Re: application 312112: Station Road, Portmarnock, Townlands of Drumnigh, Maynetown and Portmarnock, Co. Dublin. (www.portmarnocksouthphase1d.com)

I refer to the above application and make the following observations:

DRG. TITLE
ENTRANCE ROUNDABOUT
GENERAL ARRANGEMENT

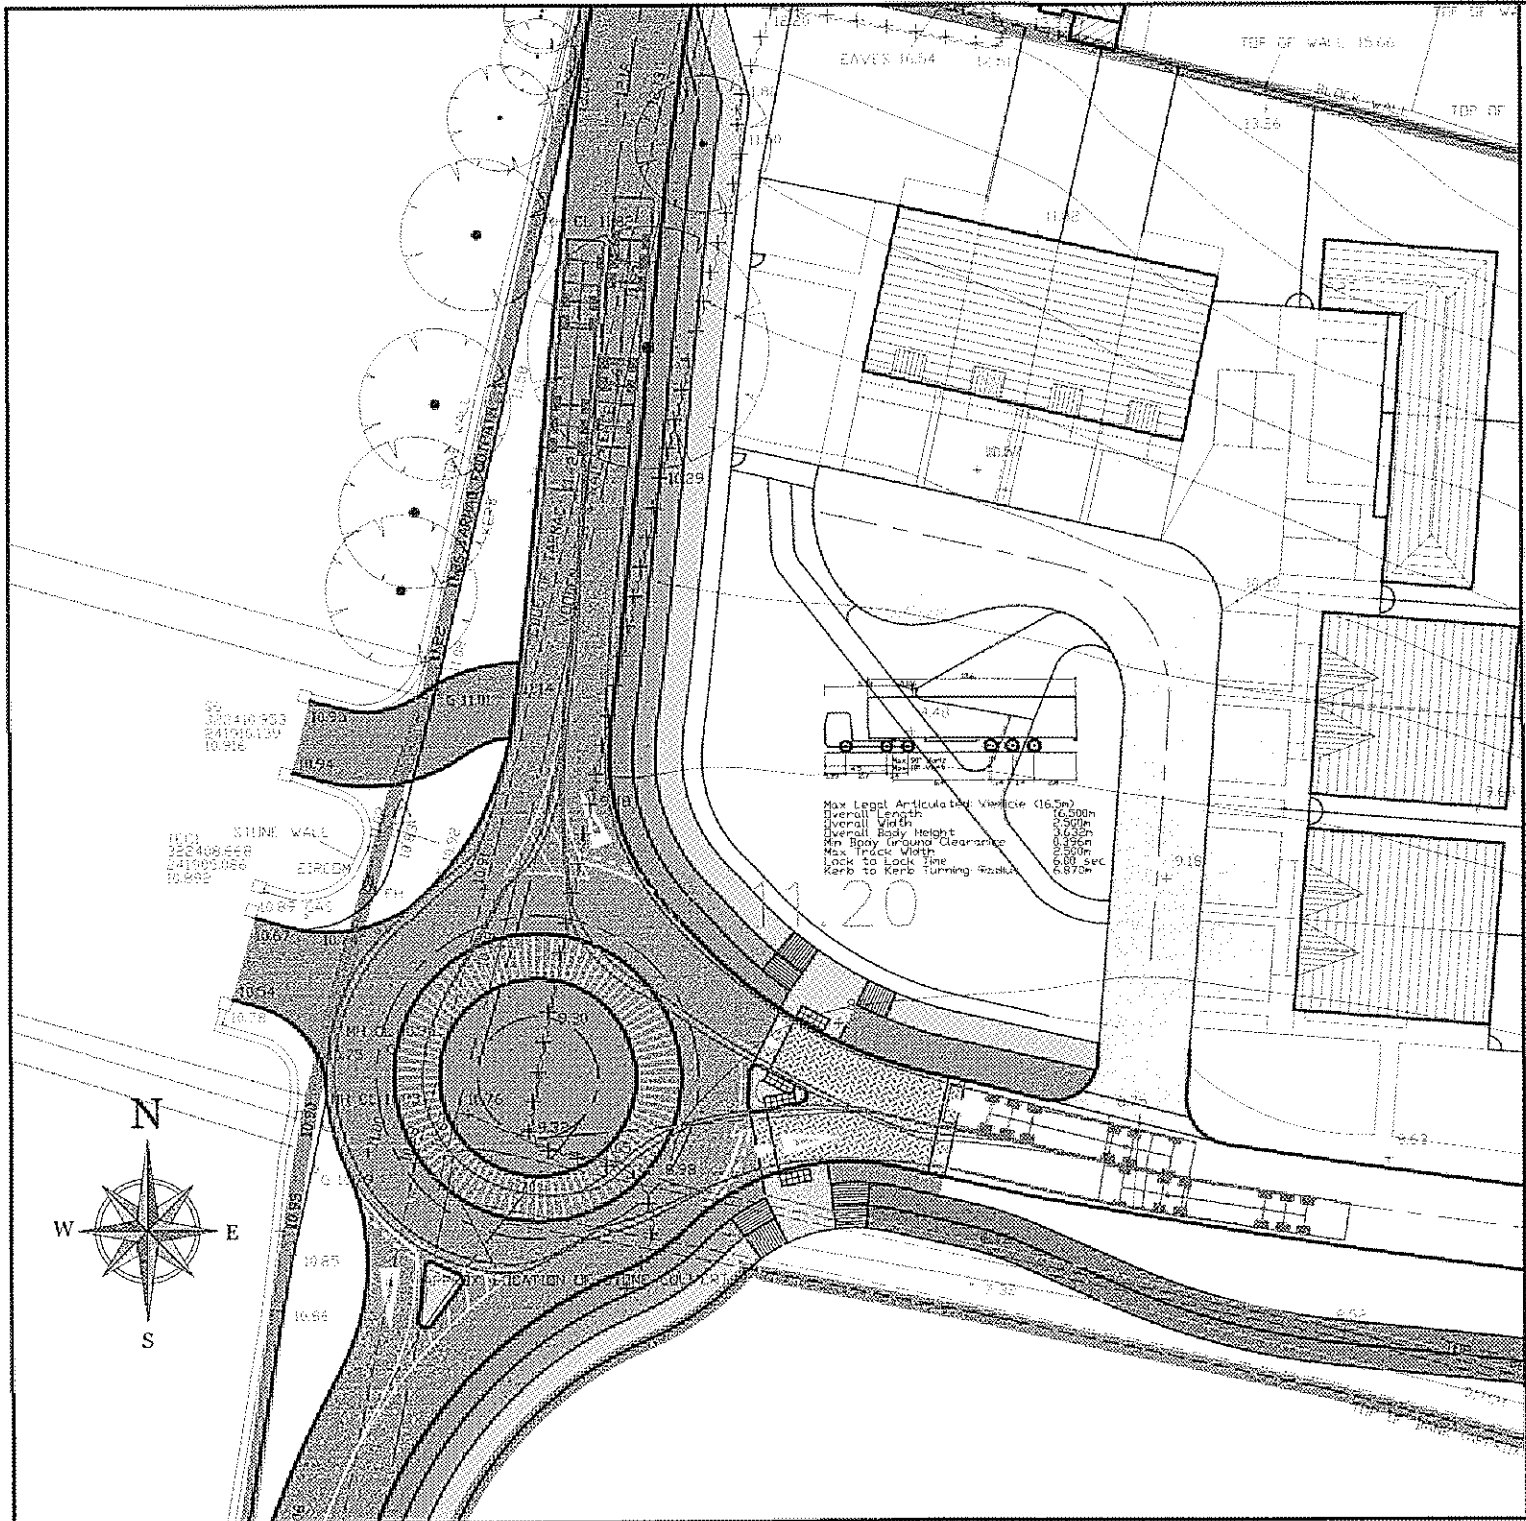
3. At the north-east of the overall Local Area Plan/ development area, the plan is to link the Baldoyle to Portmarnock Greenway to the cycleway on Station Road. Unfortunately the online documentation for permission ABP 300514 (Fingal reference SHD/002/17) is far from complete, but it appears from the Compliance Drawings and Maps put online by Fingal on 13th June 2018 that this link is part of that permission. I urge you to ensure that this link is

completed as it will provide a means for pedestrians from this development and the phases already built, travelling to the nearest primary school, St. Marnock's, to cross the road. I note from the map in the Planning Report and Statement of Consistency submitted in this application that there is a risk that this link could be considered to be in the last phase of this development. That would mean putting pedestrians at risk unnecessarily. Completion of this link, which is on land owned by this developer, in the initial phase of development should be a condition of this permission.

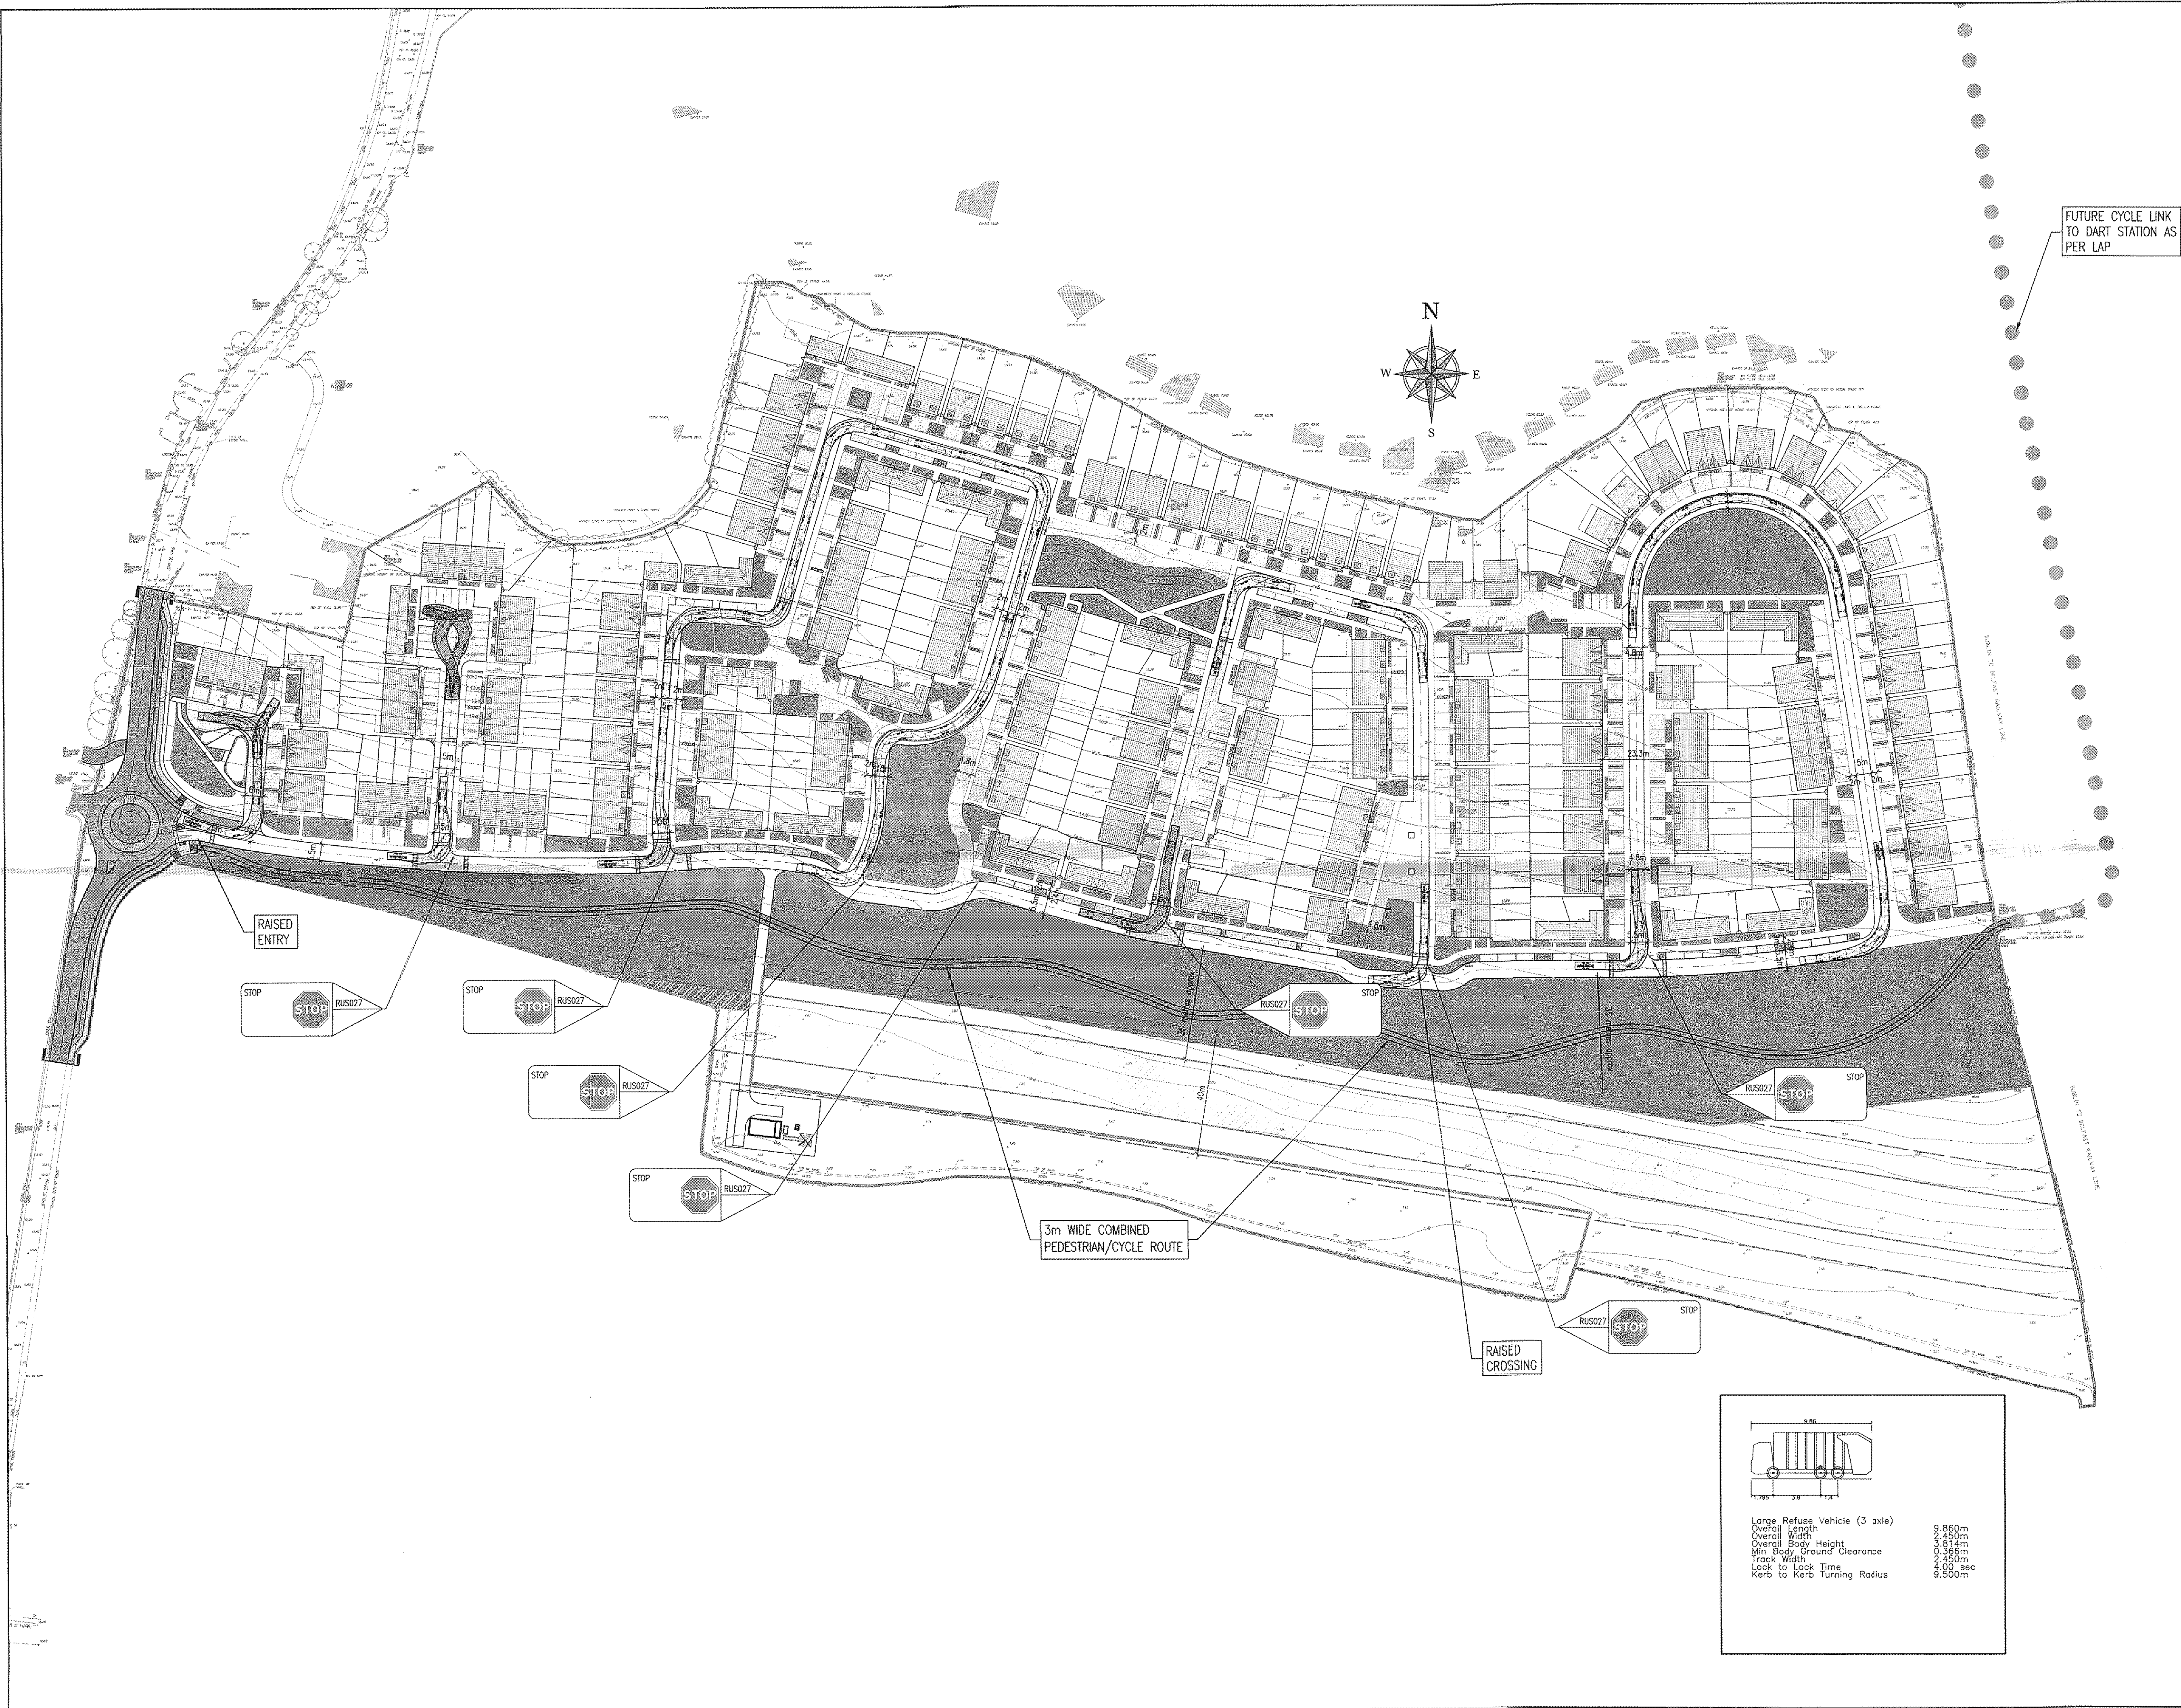
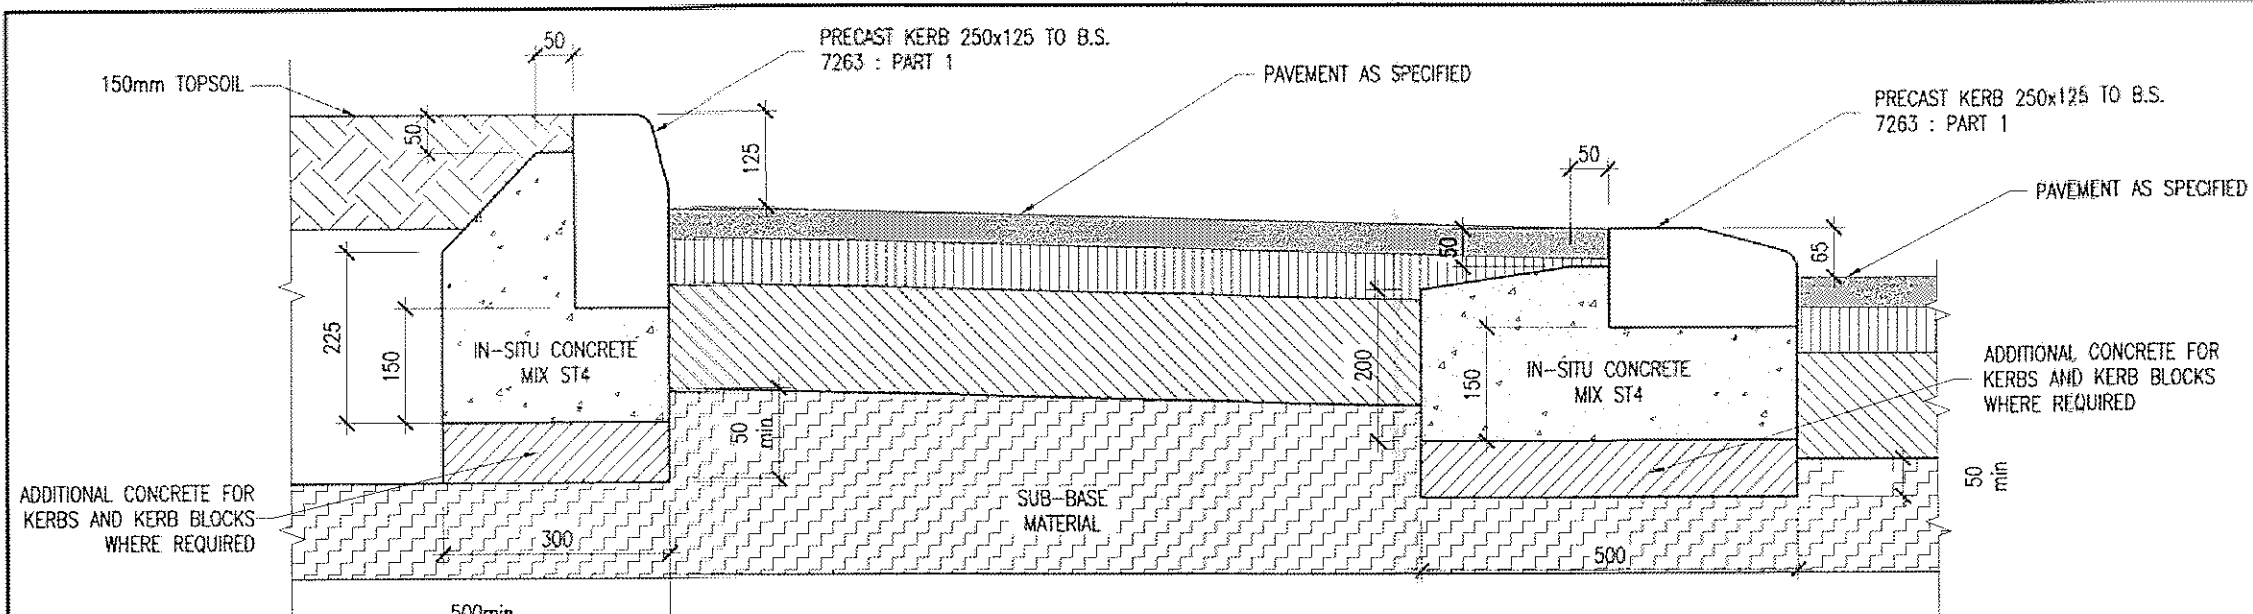
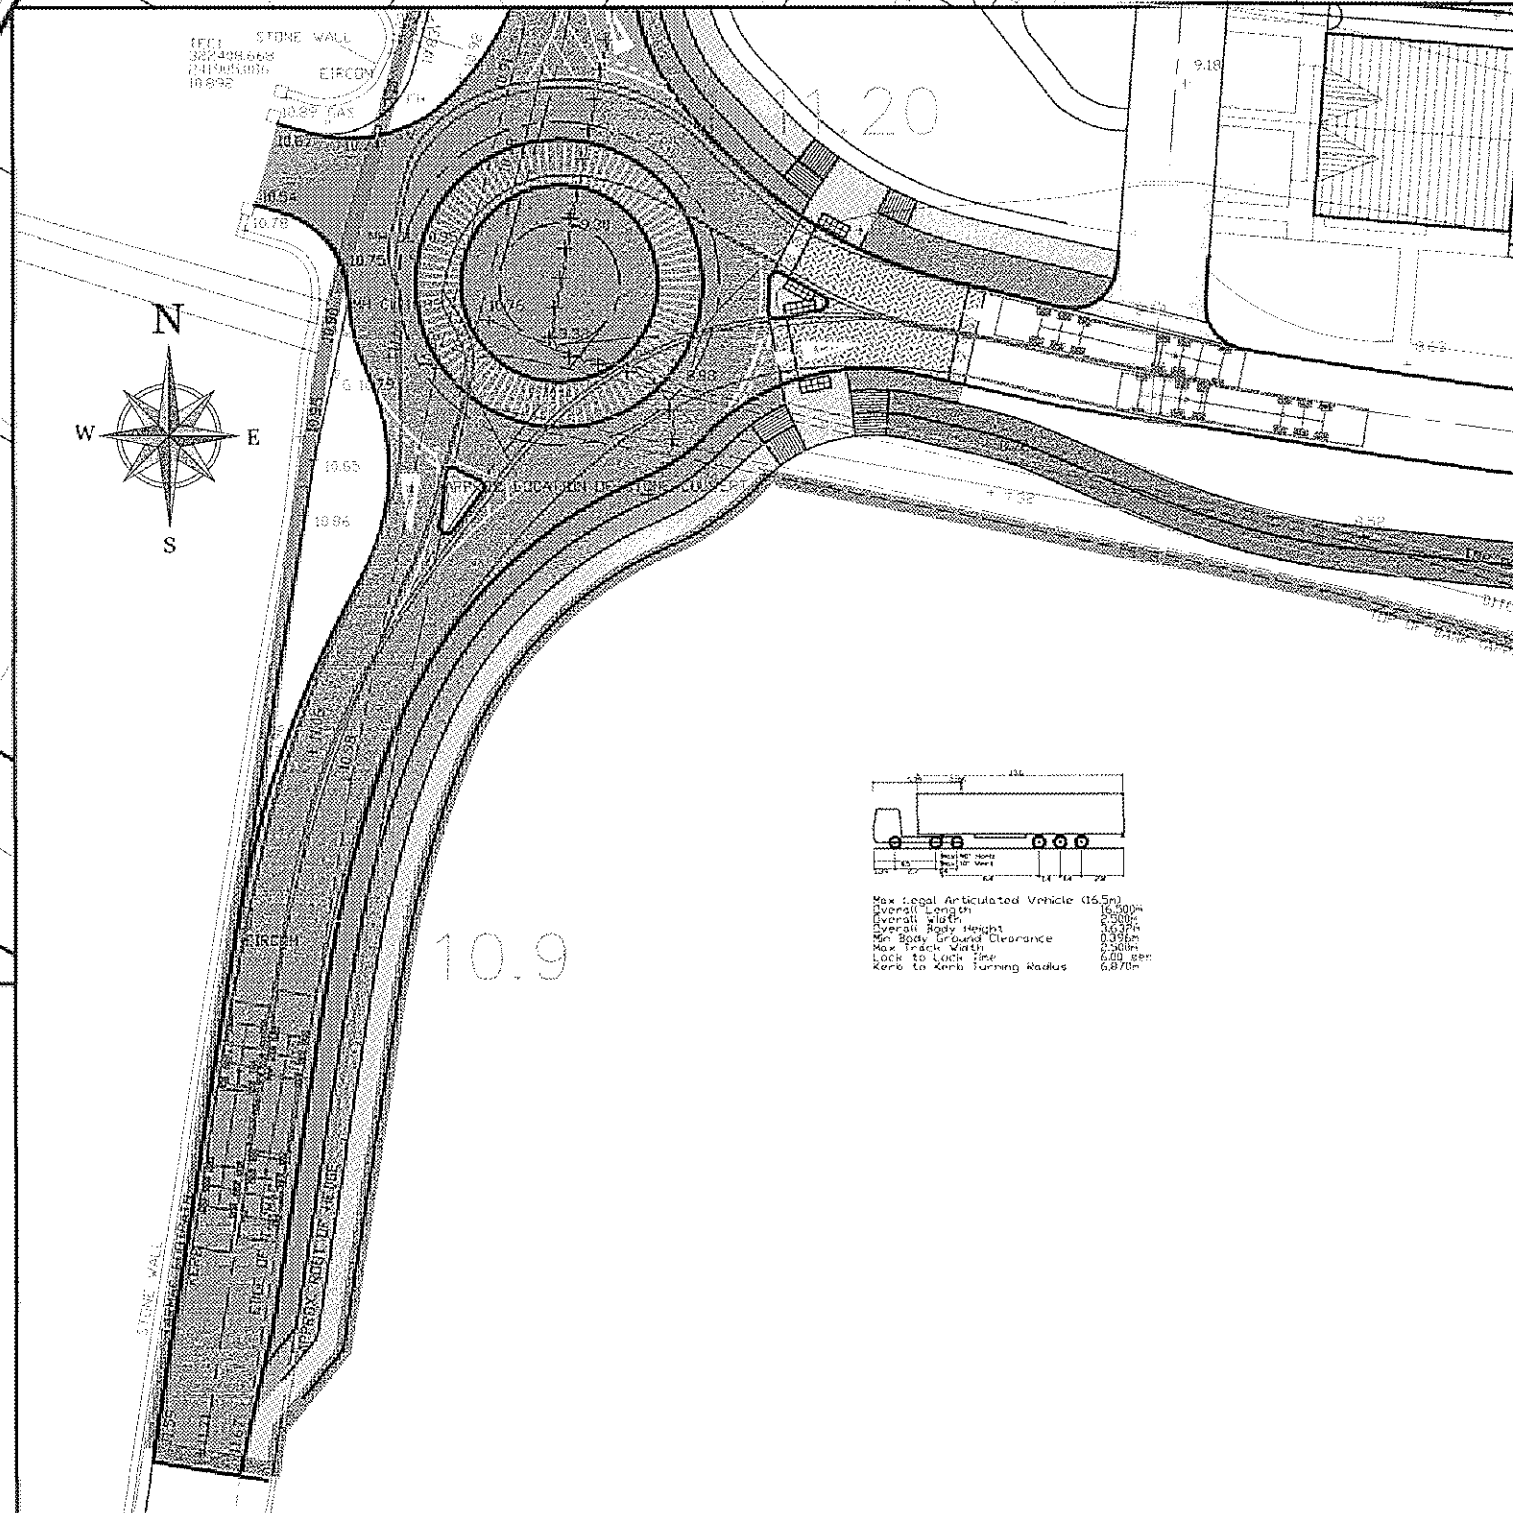
Details of the roundabout design should be provided to ensure the overrun strip is adequate to provide the entry deflections required to slow the entry speeds of traffic traveling on Drumnigh Road.
